SITE PLAN & ARCHITECTURAL  
COMMISSION  
AGENDA  
NOVEMBER 1, 2019

**Project** Sacred Heart: Faith Formation Center  
Applicant: Sacred Heart of Jesus Christ Catholic Church  
Applicant: Rogue Planning & Development Services

**File no.** AC-19-060

**To** Site Plan and Architectural Commission *for 11/01/2019 hearing*

SHEET NAME:  
**PRELIMINARY  
SITEPLAN  
DETAIL**

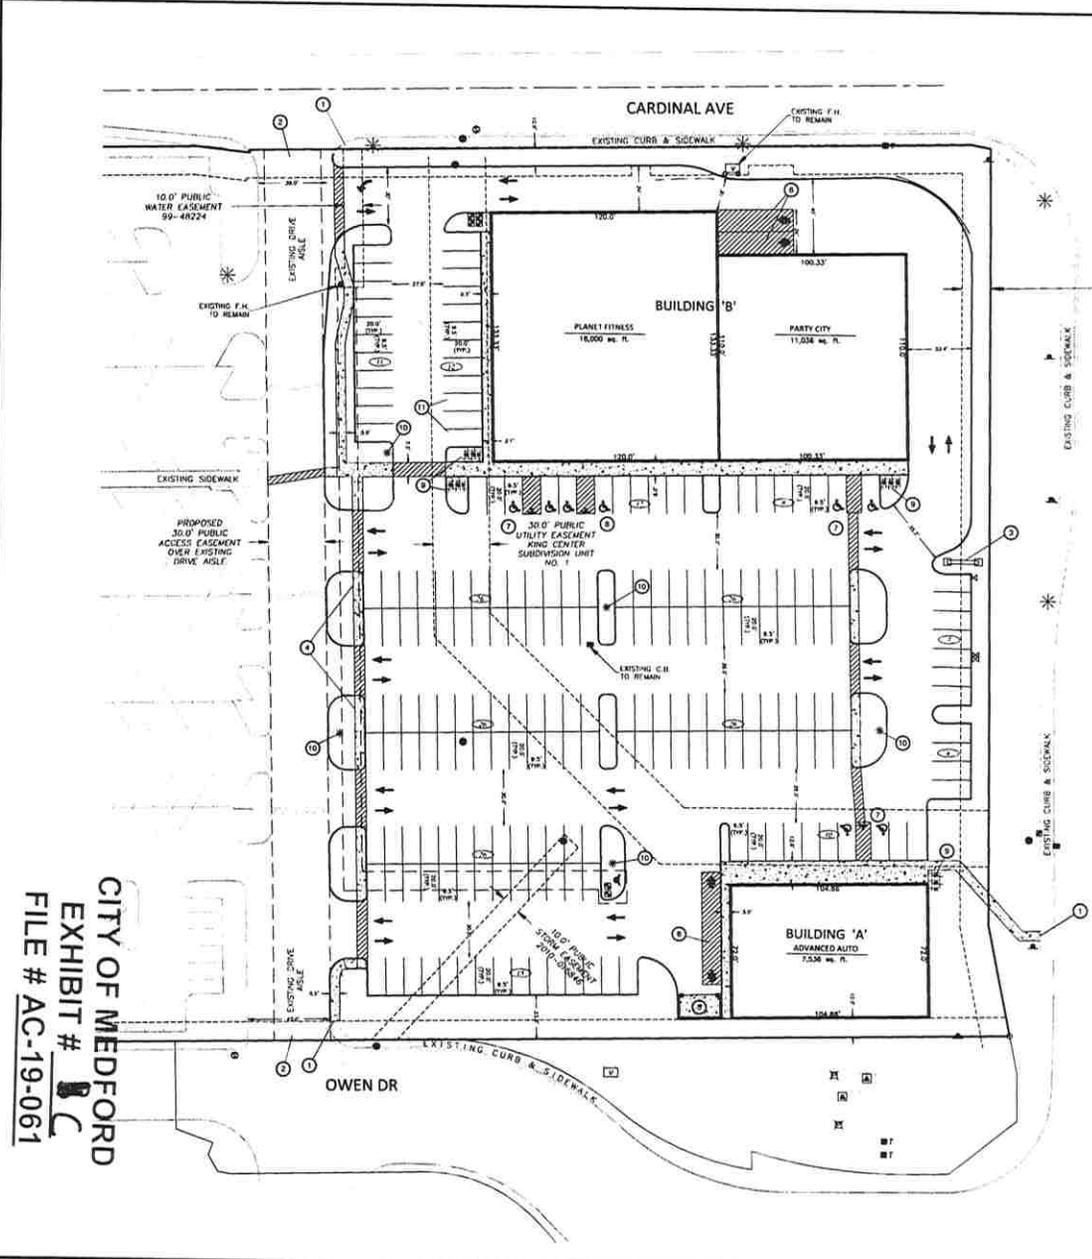
The submitted site plan shows a total of 684 parking stalls for the total site (209 parking spaces for the subject area), including 18 handicap spaces, meeting the minimum/maximum range as per MLDC 743-751. The site plan also identifies the required number of bicycle spaces for the two proposed buildings.

- 8 PROPOSED ADA SPACE TO BE "WHEEL CHAIR ONLY"
  - 9 PROPOSED BICYCLE PARKING AREAS TO INCLUDE 4 SPACES AT ADVANCED AUTO, 4 SPACES AT PARTY CITY, AND 10 SPACES AT PLANET FITNESS FOR A TOTAL OF 21 BICYCLE PARKING SPACES.

**A**  
A3.0  
ROOF PLAN  
SCALE 1/4" = 1'-0"

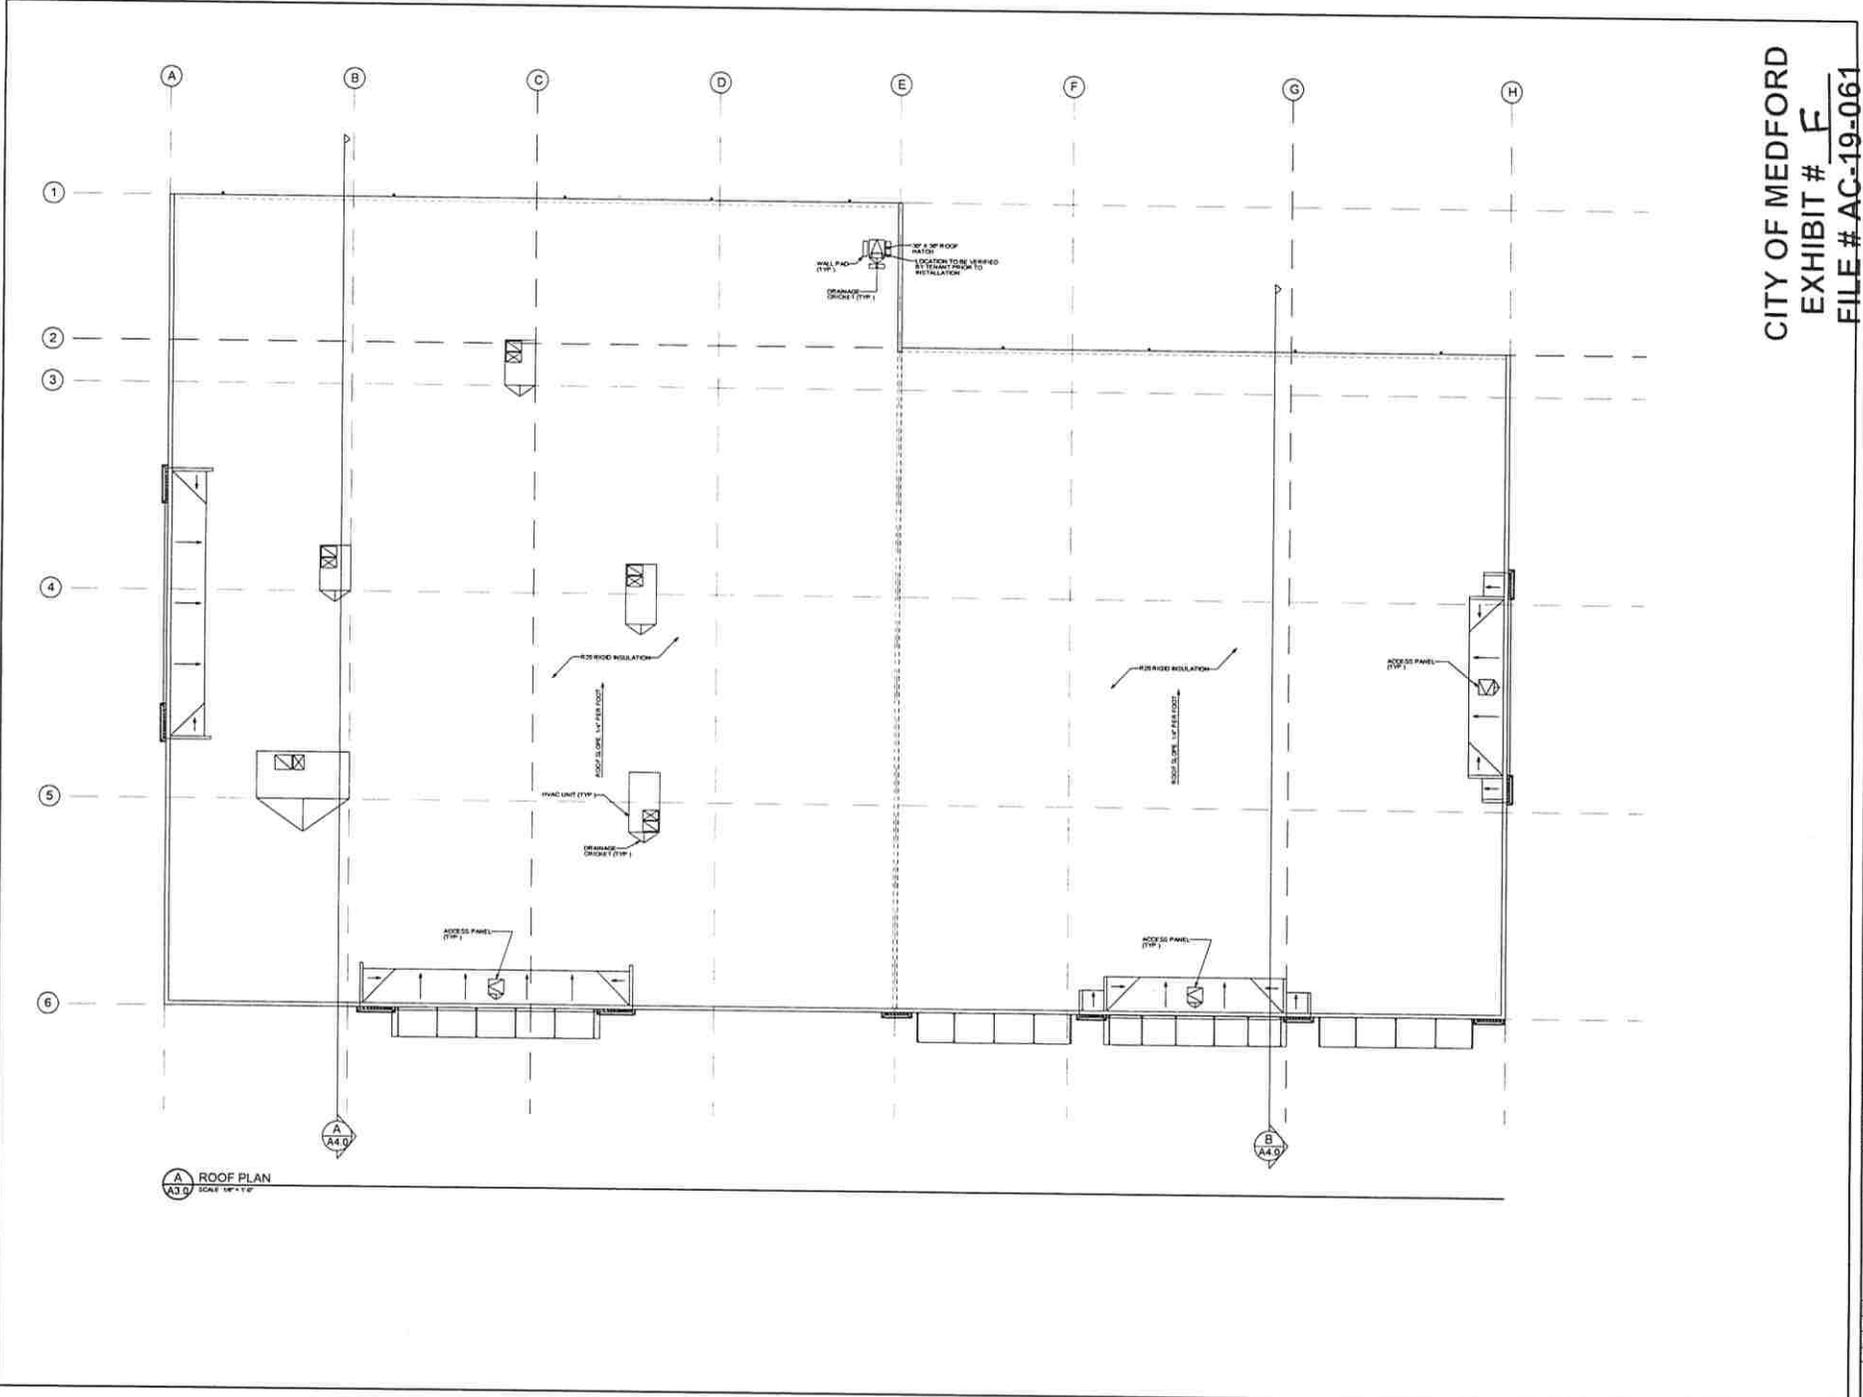
The applicant's roof plan (Exhibit F) shows the Heating, Ventilation, air conditioning (HVAC) units located on the rooftop of the building. All mechanical roof-mounted equipment is required to be concealed using the architectural elements of the building (i.e., roof forms, parapets, wing walls, alcoves, etc.). It is not clear from the applicant's elevation and roof plans if the roof mounted equipment will be adequately concealed.

As a condition of approval, the applicant will be required to submit additional elevation plans, demonstrating compliance with MLDC 10.782 prior to the issuance of building permits for vertical construction.

1. Comply with all conditions stipulated by the Public Works Department (Exhibit L).
2. Comply with all conditions stipulated by the Medford Water Commission (Exhibit M).
3. Comply with all requirements of the Medford Fire Department (Exhibit N).
4. Comply with all requirements per the Floodplain memo (Exhibit O).
5. Comply with all requirements of the Oregon Department of Transportation (ODOT) (Exhibit P).
6. Submit an elevation plan showing all proposed roof-mounted equipment concealed consistent with the requirements outlined in MLDC10.782.

SPAC LANDSCAPE PLAN

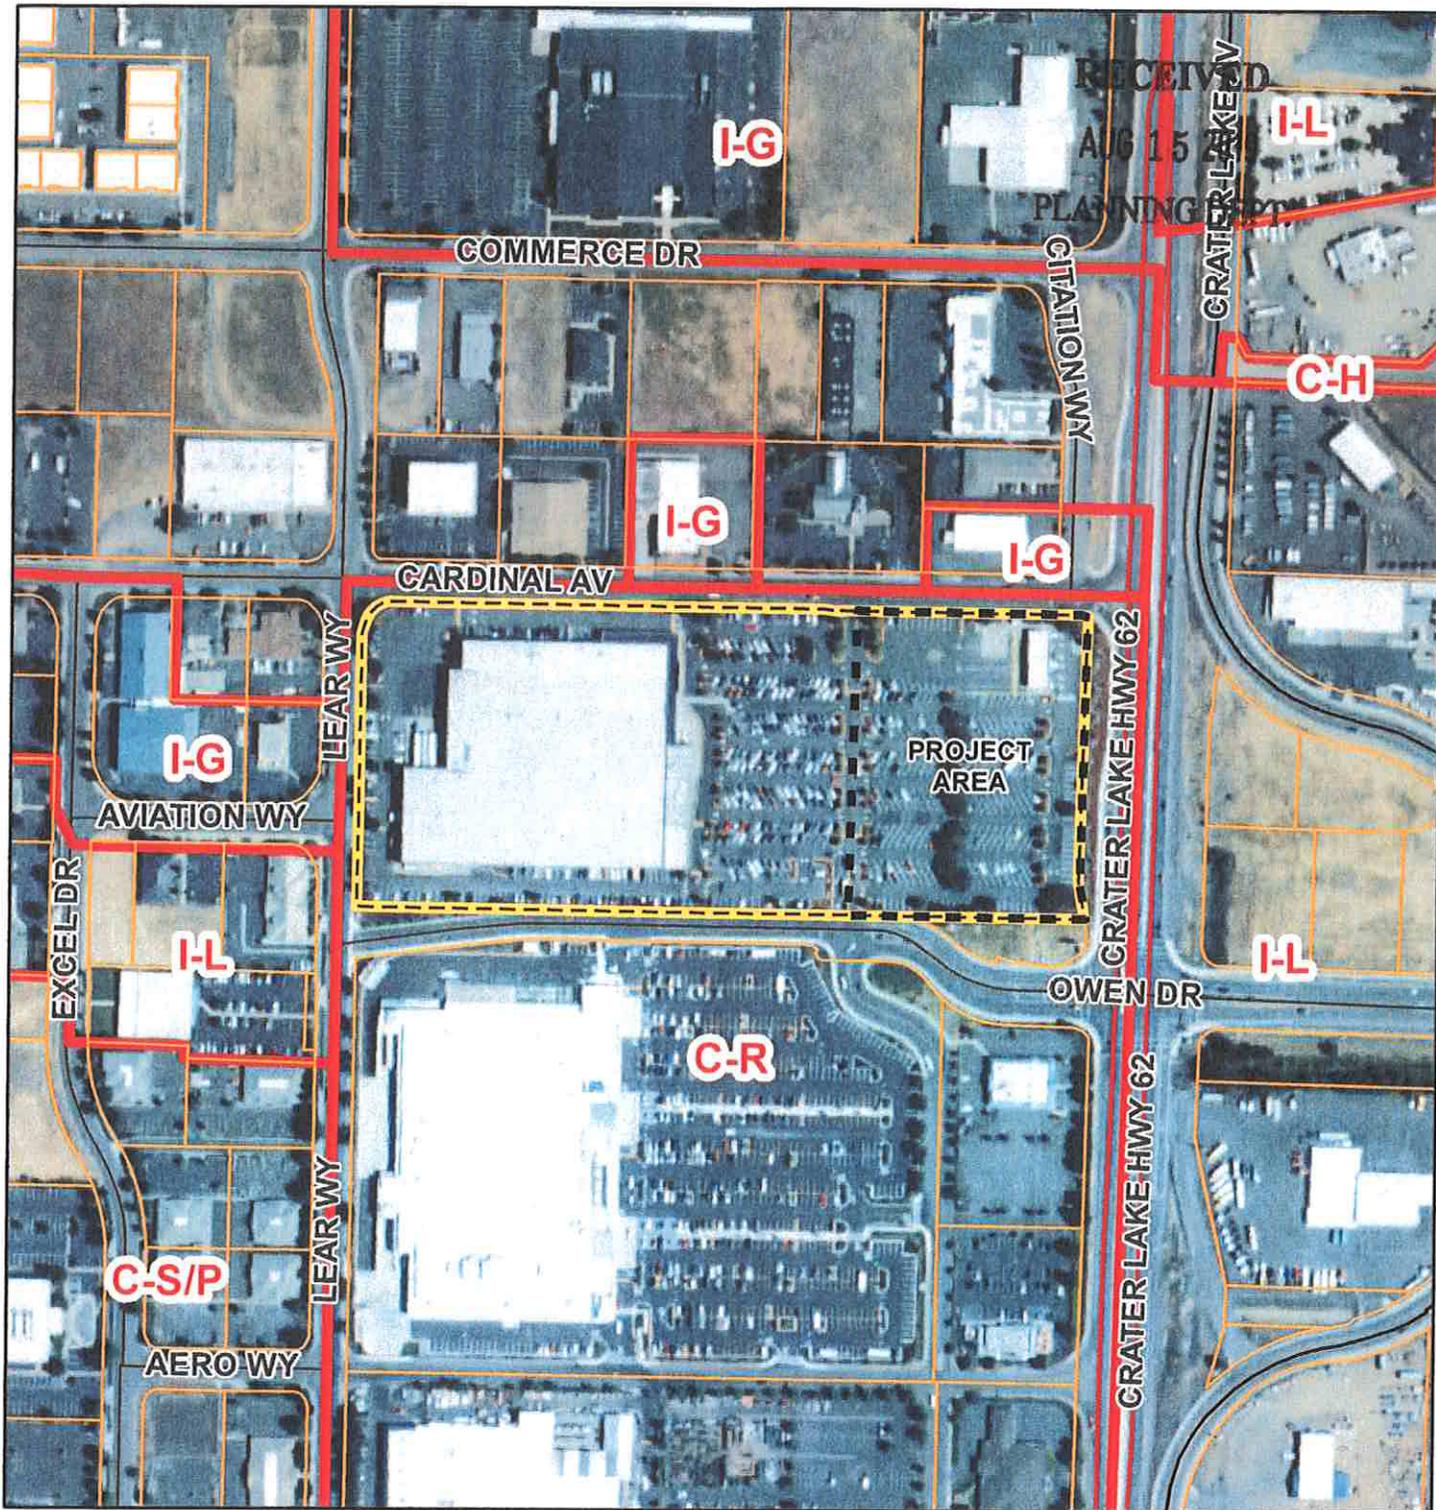
The applicant's submitted landscape plan (Exhibit H) shows landscaping along all three street frontages, meeting the minimum required number of trees and shrubs as per MLDC 10.797. The landscape plan also shows interior landscaping, meeting the required number of trees, shrubs, and total landscaping within the site's parking lot as per MLDC 10.746(3).
